# SEQUAL

## Topical Report

### **Basis for Adoption of the Experience-Based Seismic Equipment Qualification (EBSEQ) Methodology by Non-A46 Nuclear Power Plants**

**SEQUAL Owners Group**

Figure 5-1. Comparison of New Free-Field Spectra Estimates for Sylmar Converter Station and Rinaldi Receiving Station Sites with SSRAP Report Estimates

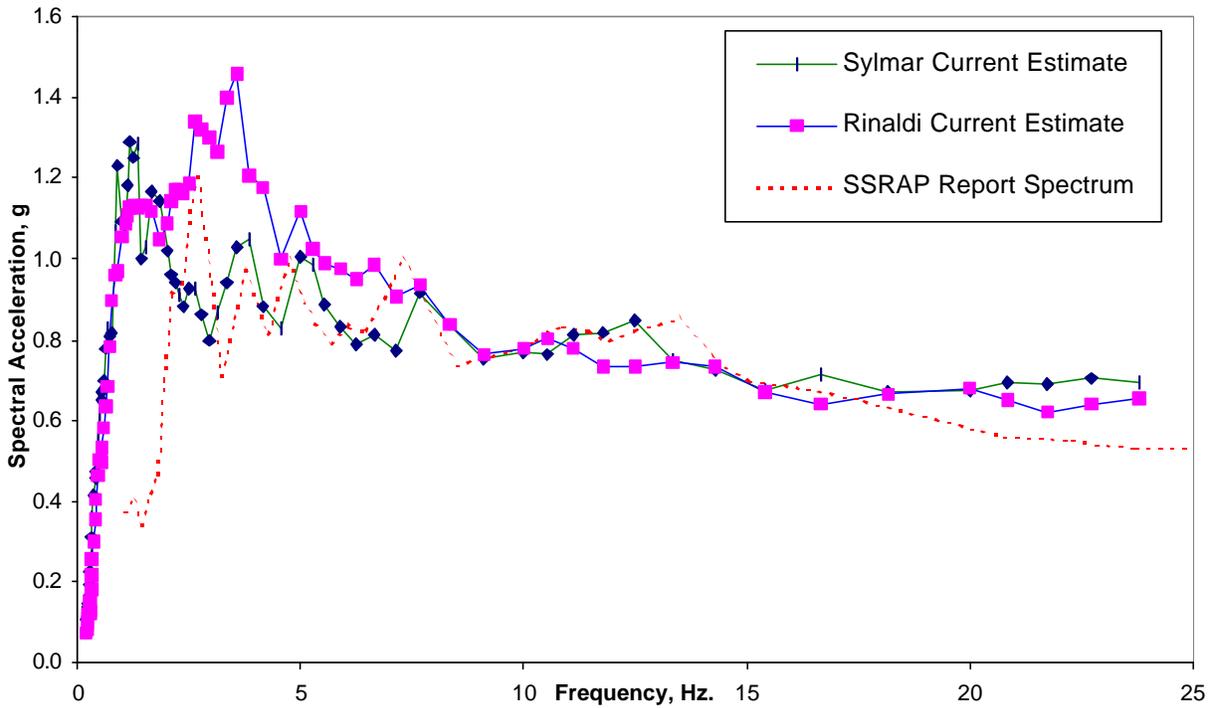
### **SEQUAL Response:**

Figure 5-1 shows a comparison of the new free-field spectra estimates for Sylmar Converter Station and Rinaldi Receiving Station sites with the spectrum used by SSRAP.
